## Metering Dispensation D/531 – Lister Drive Synchronous Compensation Units (SCUs)

### Imbalance Settlement Group (ISG)

Paper number **250/03**

**Statkraft Market GmbH has applied for a lifetime Metering Dispensations (D/531) against Code of Practice (CoP) 1. D/531 is for the location of the CoP1 metering for two new Synchronous Compensation Units (SCUs) at Lister Drive. We invite the ISG to approve Metering Dispensations D/531 on a lifetime basis, subject to a condition.**

2.2 A full single line diagram is attached as an appendix to this paper (Attachment B), but a sketch is shown below:

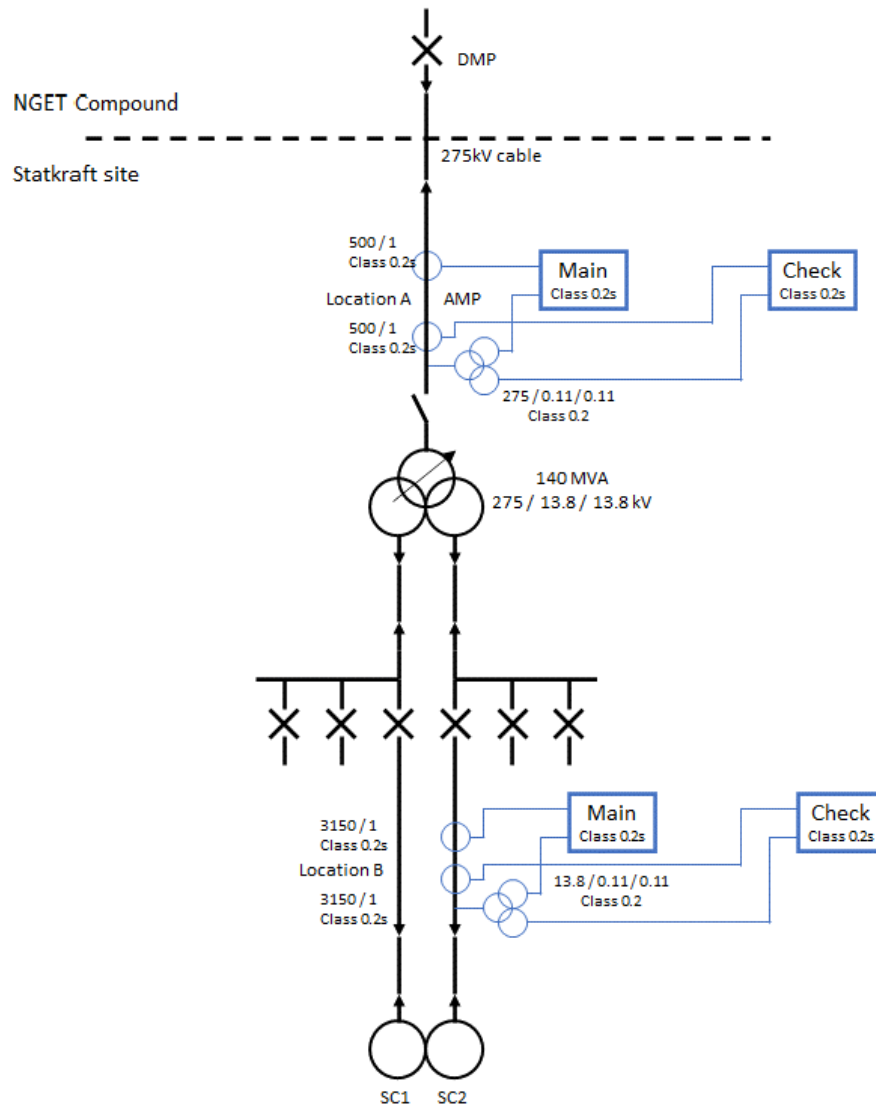
- 2.5 It is proposed that the total Import / Export MWh and MVARh is metered at Location A in the above sketch.
- 2.6 It is also proposed that metering of one of the SCUs (SCU2) will be located on the low voltage side of the power transformer – Location B in the above sketch. The measured values at Location B will be corrected (for MWh and MVARh) as if the measurement had been at the DMP. The difference between the values for the total Import / Export at the DMP (corrected from the measured values at Location A) and the corrected measurements at Location B will be allocated to the other SCU (SCU1).

- 2.7 There are two auxiliary power systems (for redundancy) operated in an either / or arrangement, so all of the auxiliary load will either be supplied through the Medium Voltage (MV) switchboard of SCU1 or through that of SCU2, not half each. Metering at Location B for SCU2 means that all of the auxiliary (and start-up) power used by both SCU1 and SCU2 is allocated to SCU1. Metering at SCU1 would have the same issue – all of the auxiliary power would be allocated to SCU2. This does not affect the overall Import / Export MWh and MVArh measured at Location A.

- 3.1 This Metering Dispensation is to allow for the location of Metering Equipment associated with SCU2 (location B on the above sketch). The second reason for seeking this Metering Dispensation is to account for the distance between the location A and the DMP, for the Boundary Point Metering Equipment.

- 4.4 The MDRG stated that the split use of the secondaries means that the measurements at Point B do not "correctly" allocate the Active Energy to each BMU. Therefore the BMUs do not actually measure the separation of Active Energy that they are intending to measure, even with the Metering Dispensation. By having a Boundary Point measurement, the values of the two BMUs at the Boundary Point should sum to the correct value. The measurement at point B, plus any adjustment factor, will be deducted from measurement at point A to determine the value for "BMU A" – but if the adjustment is wrong then the allocation to both BMUs will equally be wrong.

- 4.5 The MDRG felt that the accuracy of Reactive Energy measurement will not be possible to be achieved across all 31 tap positions, without some new undefined approach to apply corrections. Equally the measurement tolerance (+/-10%) in the power transformer manufacturer's document, for the Reactive Power load losses, exceeds the BSC accuracy requirements anyway.

- 4.6.1 Elexon agree and propose to add this as a recommended condition.
- 4.7 The MDRG noted the separate Distribution System supply (as can be seen on the attachment single line diagram (SLD)) should be interlocked to not be used at same time as the Transmission System supply.

- 4.4.1 Elexon recognises that whilst Active Power may not necessarily be allocated to each SCU "correctly" (based on dynamically compensated Meter readings) the Registrant of both BMUs is the same across the two SCUs. As a result the allocation method proposed will not have an adverse impact on Settlement overall or on any other Registrants.

- 4.5.1 The applicant responded by submitting a methodology (Attachment F) showing the effect of operating the transformer tap changer at different positions to the nominal tap (used for calculating the reactive losses). The maximum error between a different tap position and the nominal tap position is 2.79%. CoP1 allows for an error of plus or minus 4% for reactive energy when operating at zero power factor (which an SCU always does). As such the applicant believes this justifies calculating the losses using the nominal tap position.

- 4.7.1 The applicant confirmed that the distribution connection would only ever be used as a backup supply to the site auxiliary transformers when the transmission network is unavailable; and that an interlocking scheme is in place to prevent accidental paralleling of the two.
